SECOND FINAL NOTICE

DATE: SEPTEMBER 14, 2015
TO: BLUE BIRD OWNERS
SUBJECT: RECALL R14XE
STEERING SHAFT CLAMP MAY CONTACT RUBBER
CLOSEOUT BOOT

IMPORTANT SAFETY RECALL NOTICE

Steering Shaft Floor Boot Seal

Fig. 1

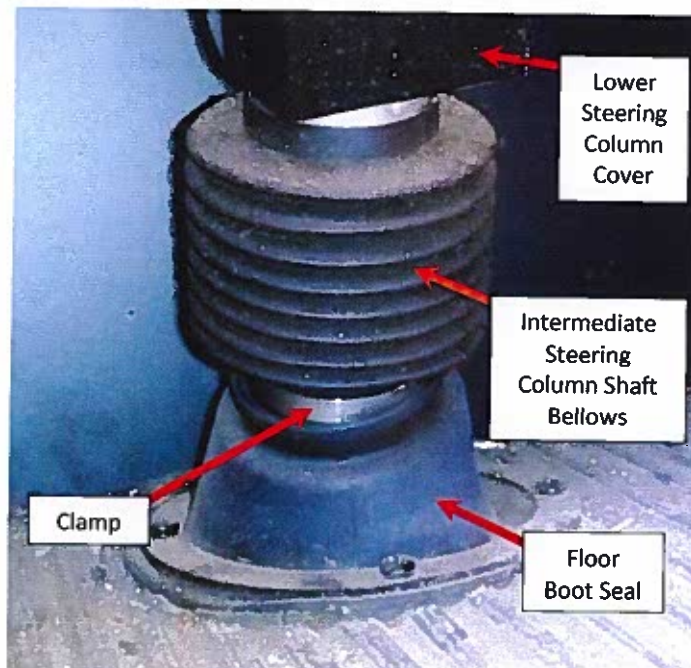
1. Park bus on a level surface, apply parking brake, turn off ignition, remove ignition key and chock rear wheels.
2. Inspect steering shaft floor boot seal for wear or damage and slit is toward front of bus.
3. If damaged or worn, complete section **Steering Shaft Floor Boot Seal Replacement** before continuing.
4. After completing section **Steering Shaft Floor Boot Seal Replacement** or if there is no damage or wear to the floor boot seal, complete section **Intermediate Steering Column Shaft Bellows Adjustment**.

Fig. 2

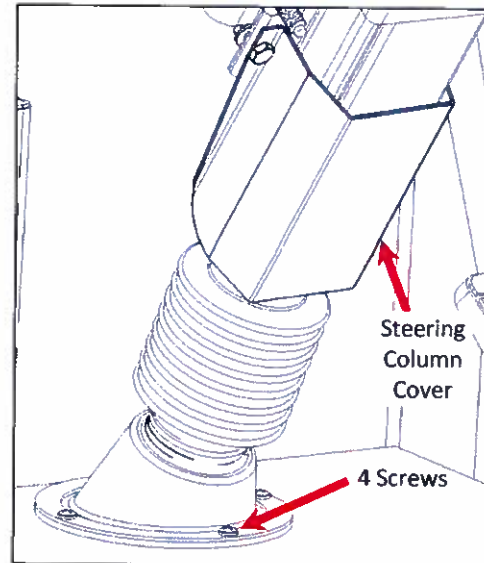
1. Remove lower steering column cover and discard fasteners. (Fig. 2)
2. Remove four screws from steering shaft floor boot seal retaining ring. Boot seal and retaining ring should be loose from floor. Keep screws for re-use. (Fig. 2)
3. Remove pinch bolt and nut from upper portion of intermediate shaft. Discard bolt and nut. (Fig. 3)
4. Remove pinch bolt and nut from lower portion of intermediate shaft. Discard bolt and nut. (Fig. 3)
5. Compress intermediate shaft together while removing it from splines on steering column and transfer box.
6. Pull intermediate shaft up through hole in floor.
7. Cut off bellows clamp on lower section of intermediate shaft. (See Fig. 3)

Fig. 4

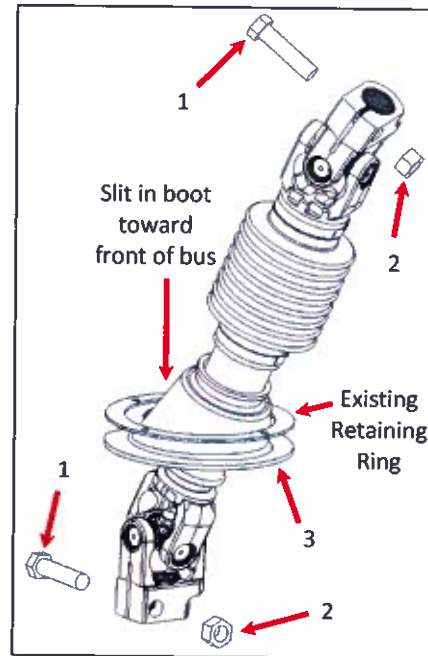
8. Replace floor boot seal on intermediate steering shaft and re-install intermediate shaft using new fasteners. (See Fig. 4)
 - a. Torque pinch bolts 36-43 FT-LBS.
9. Re-install floor boot seal with retaining ring with four screws. Slit in floor boot seal should be oriented toward front of bus. (See Fig. 5)
10. Install lower steering column cover with new fasteners. (Fig. 6)
 - a. Torque nuts to 37-41 FT-LBS.

Fig. 7

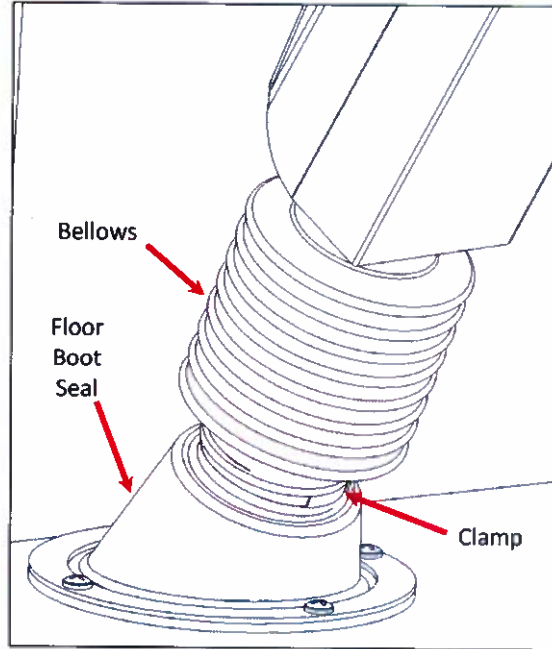
1. Cut off bellows clamp on lower section of intermediate shaft if present. (Fig. 7)
2. Push bellows up until it is no longer in contact with steering shaft floor seal boot.
 - a. Minimum 0.50 inch gap between floor seal boot and bellows.
3. Open new worm gear clamp until it releases then secure it around bellows. (Fig. 8)
 - a. New clamp must ride all the way around in groove on bellows.
 - b. Torque clamp to 10-15 in-lb.
4. Inspect the floor boot seal and bellows for minimum 0.50 inch clearance all the way around the intermediate steering column shaft.
5. Recall is complete. Place bus back into service.
